### SB EC135-31-091

# SERVICE BULLETIN

### INDICATING AND RECORDING SYSTEMS - Instrument Panels Replacement of switches on the switch unit 20VE

Revision No.	Date of issue
Revision 0	2020-11-04

Replacement of the engine switches  
Figure 1

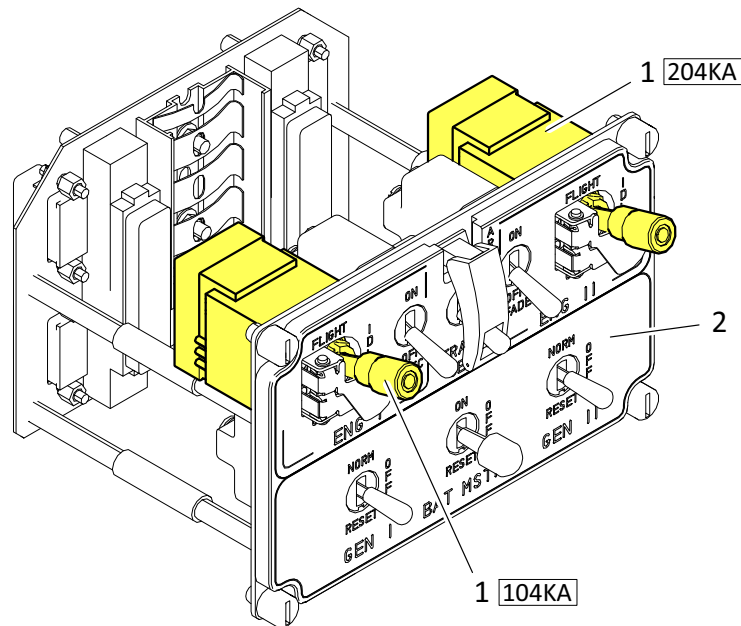
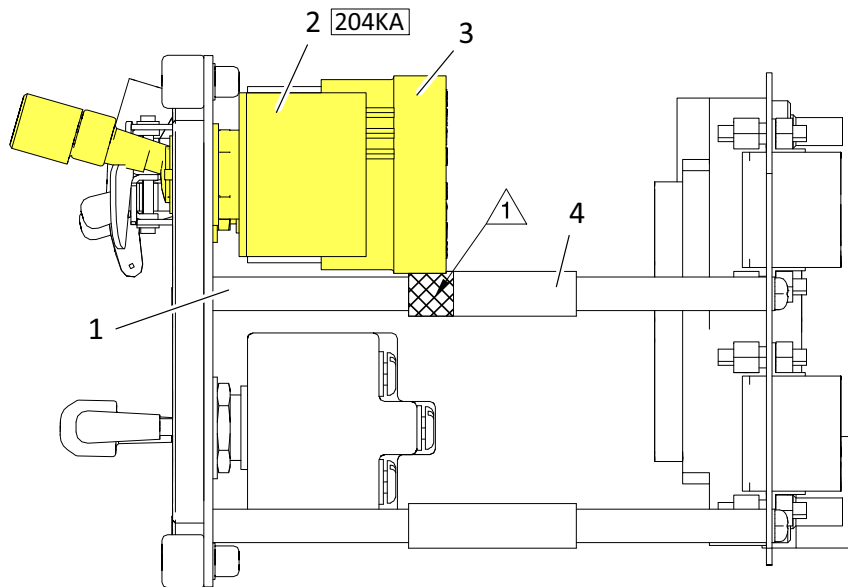
1. Replacement of the engine switches (1, Fig. 1):

- a. Remove and discard the existing engine switches (1) 104KA and 204KA from the switch unit 20VE (2) (AMM 31-11-20, 4-3). Respect the MTC 20-80-20-101 during the disconnection of the concerned wires.

- b. Install the improved engine switches (1) 104KA and 204KA on the switch unit 20VE (2) (AMM 31-11-20, 4-3). Respect the MTC 20-80-20-101 during the connection of the concerned wires.

**Pre SB**  
SWITCH PIN ASSIGNMENT

**Post SB**  
SWITCH PIN ASSIGNMENT
